Product Change Notice

Issue Date: 1-August-2022

Introduce new die source and new phosphor

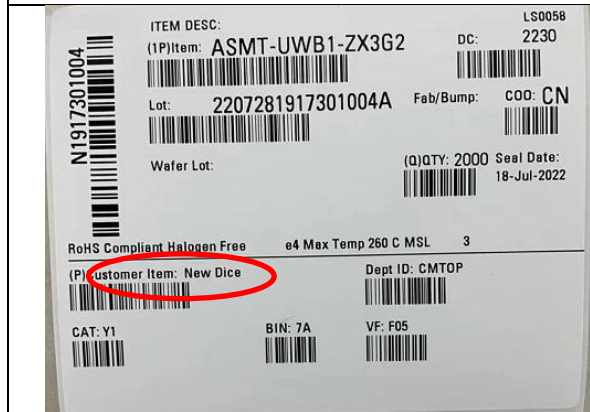
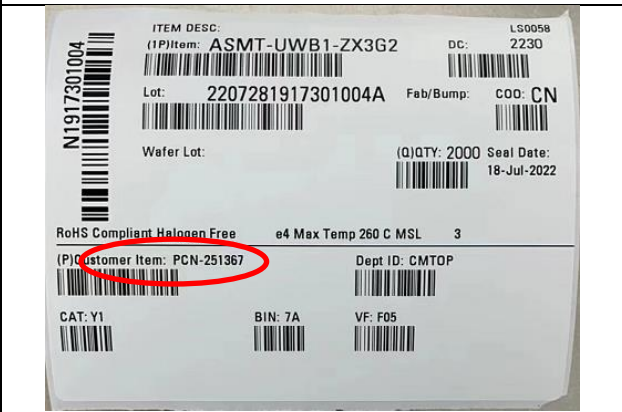
Different packing label to indicate Post PCN part as shown in diagram below

Pre-PCN	Post PCN
 <p>ITEM DESC: LS0058 (1P)Item: ASMT-UWB1-ZX3G2 DC: 2230 Lot: 2207281917301004A Fab/Bump: C00: CN Wafer Lot: (Q)QTY: 2000 Seal Date: 18-Jul-2022 RoHS Compliant Halogen Free e4 Max Temp 260 C MSL 3 (P)Customer Item: New Dice Dept ID: CMTOP CAT: Y1 BIN: 7A VF: F05</p>	 <p>ITEM DESC: LS0058 (1P)Item: ASMT-UWB1-ZX3G2 DC: 2230 Lot: 2207281917301004A Fab/Bump: C00: CN Wafer Lot: (Q)QTY: 2000 Seal Date: 18-Jul-2022 RoHS Compliant Halogen Free e4 Max Temp 260 C MSL 3 (P)Customer Item: PCN-251367 Dept ID: CMTOP CAT: Y1 BIN: 7A VF: F05</p>
